QC-RST-023

WRONG DEFINITION OF FREE SPACE ABOVE DRAW HOOK

TÜV SÜD Nederland

TSI LOC&PAS 1302/2014, amended
by Regulation (EU) 2019/776 and/or
Regulation (EU) 2020/387

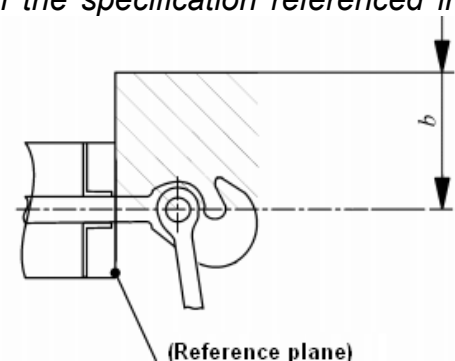
The definition of the requirement “free space” in chapter 6 of [1] is wrong because it uses a reference plane that fits to standard freight wagons (origin UIC 521 for freight wagons) and also, the definition of the free height is extremely simplified (≥ 395 mm, which is far away from existing locomotives) as represented in fig. 7 of [1], recalled opposite:

with $b \geq 395$ mm for locomotives

Example 1:

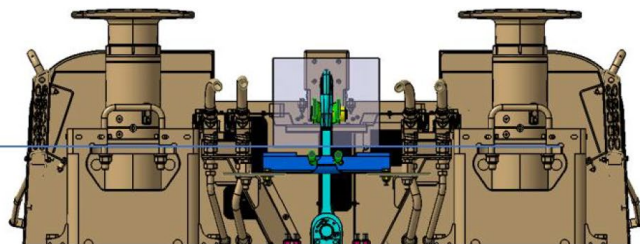
This reference plane (buffer fixing plane), derived from freight wagons, does not make sense for locomotives or EMUs/DMUs – which have to be equipped with crash buffers instead of standard UIC freight wagon buffers. See the following examples of different buffer fixing planes in locomotives (pictures by courtesy of Bombardier).

→ Existing rolling stock does not comply with these clearance requirements !

buffer fixing plane

Example 2:

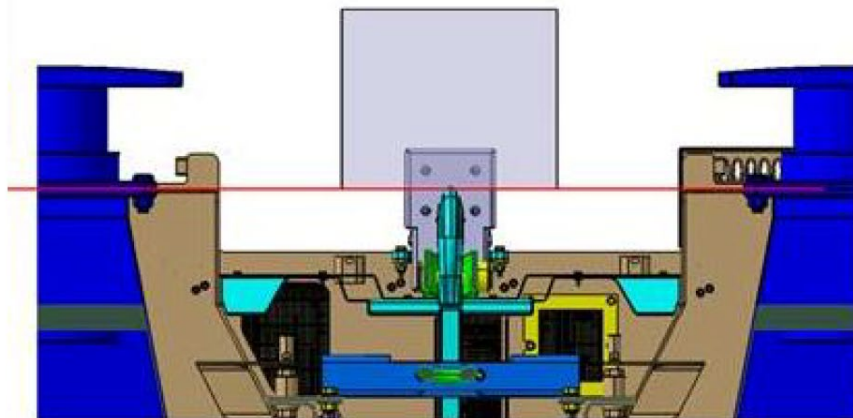
→ Required clearance in depth is not necessary in operation / for plugging in type 10 adapter !

buffer fixing plane

Clearance definition:

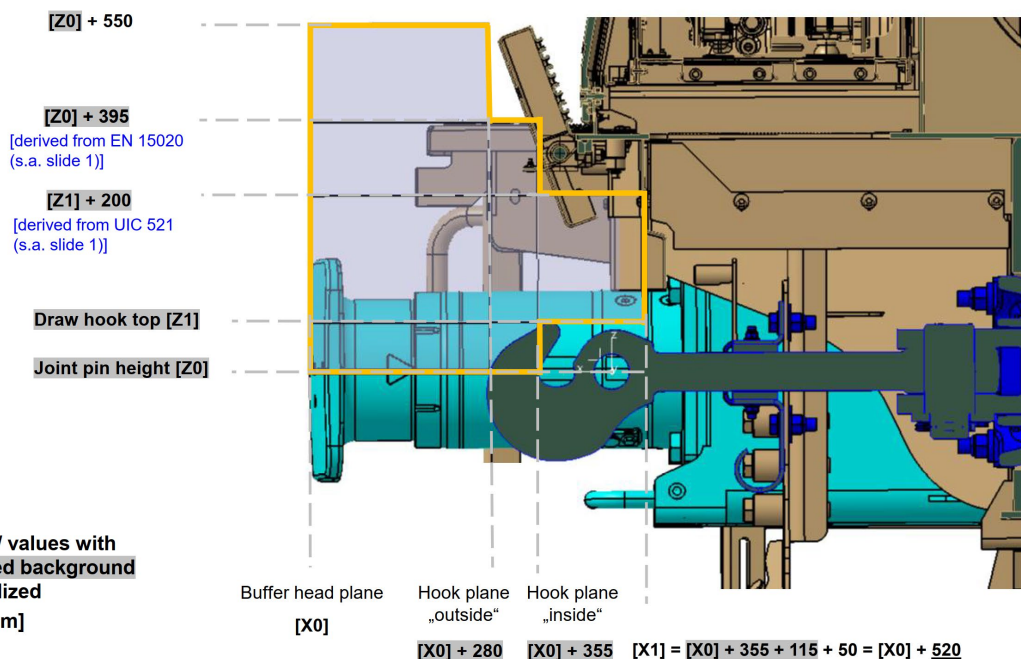
Besides the action from CEN working group to correct the EN 16839, the railway sector needs urgently a solution to the reference plane issue. How can this be achieved?

- using the buffer plate (which is the same for all type of rolling stock) instead of the buffer flange plane (which is different depending on the type of the crash-box to crash-buffer interface or the different crash systems on the market) and
- defining the free space where it is really needed.

The following picture describes the free space that is really needed – with reference plane at the buffer plate and adapted height requirements (picture by courtesy of Bombardier):

- Parameters / values with grey coloured background are standardized
- Values in [mm]
